Addendum 01

DOCUMENT 00 91 00

PROJECT: Clermont County Facilities Phase 3
CTC Building and Canopy
4019 East Filager Road
Batavia, OH 45103

PROJECT #: 22001.00

SHEET NUMBER:		
C1.1

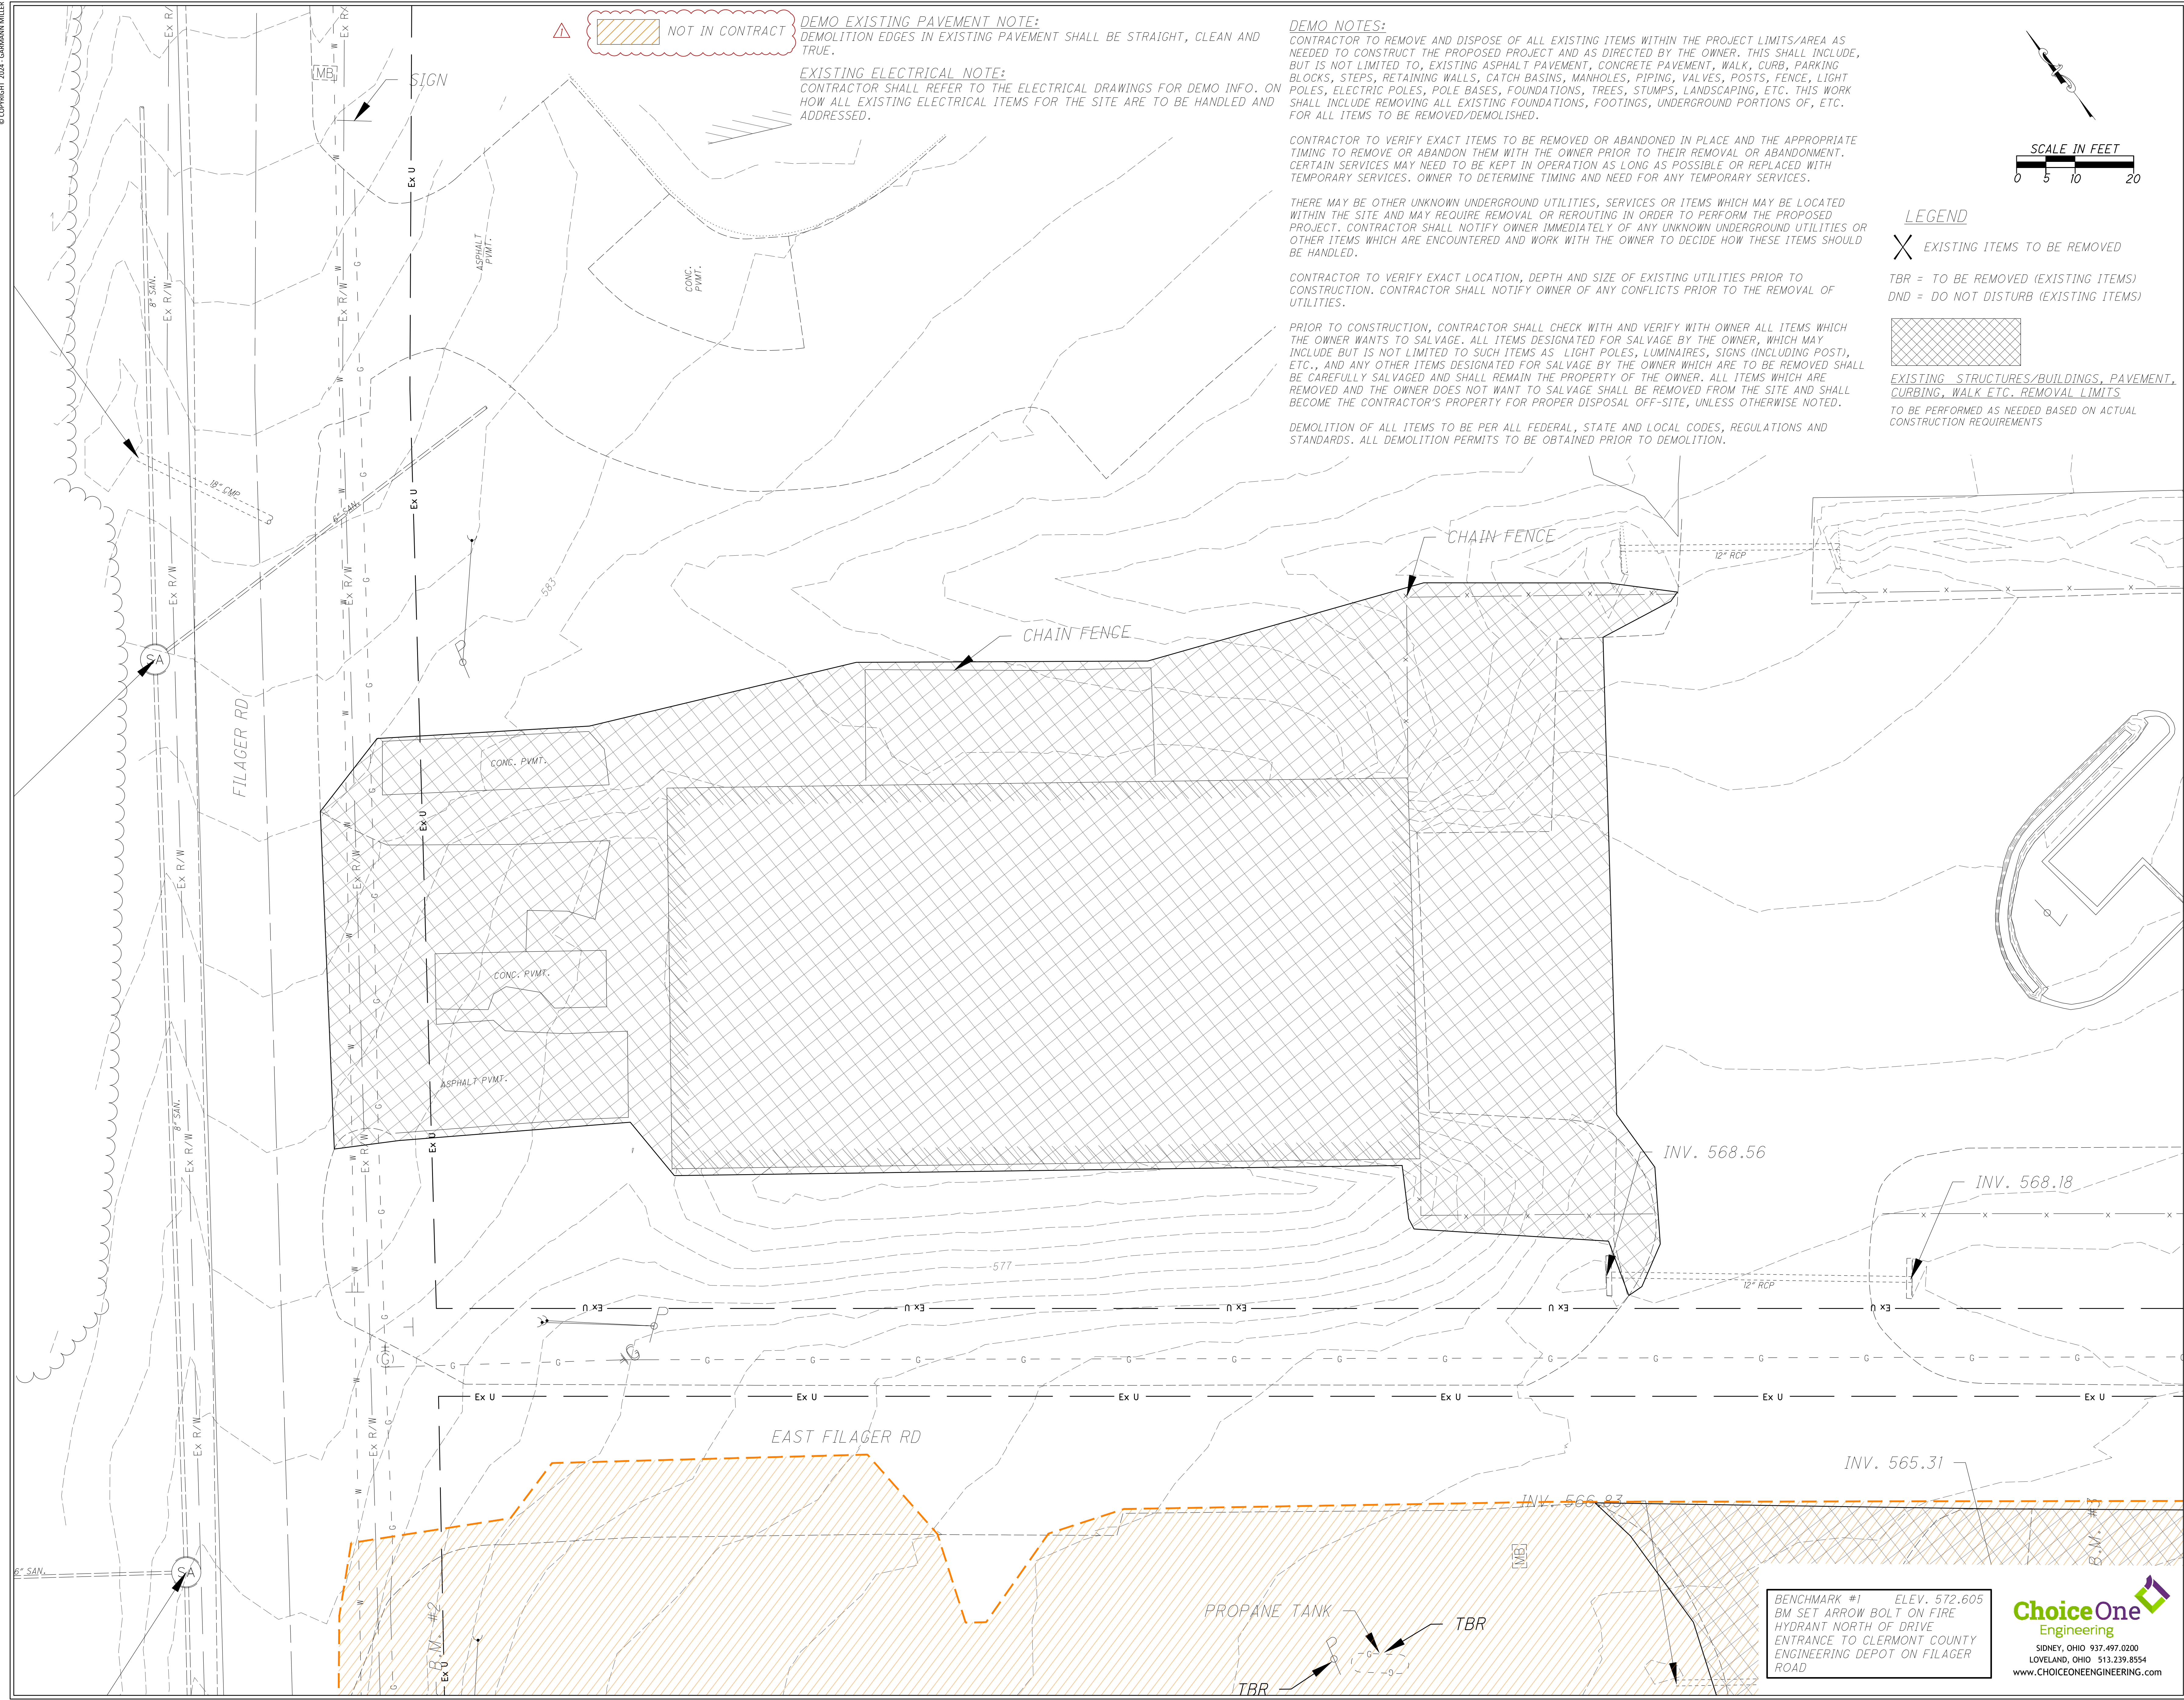
1. Drawing Sheets C1.1, C1.2, C2.1, C3.1, C3.2, C6.1 and C 7.1: A hatch pattern has been added to denote areas outside of this project scope.
2. Drawing Sheet A1.2 Canopy Plan, Roof Plan & Section – Alternate 1: Add three 10 lb class B:C fire extinguishers with mounting bracket attached to canopy column at locations shown on the plan.
3. Drawing Sheet A1.3 Floor Plan, Sections & Elevations – Alternate 1: Add helical foundation pile at each corner of storage shed.
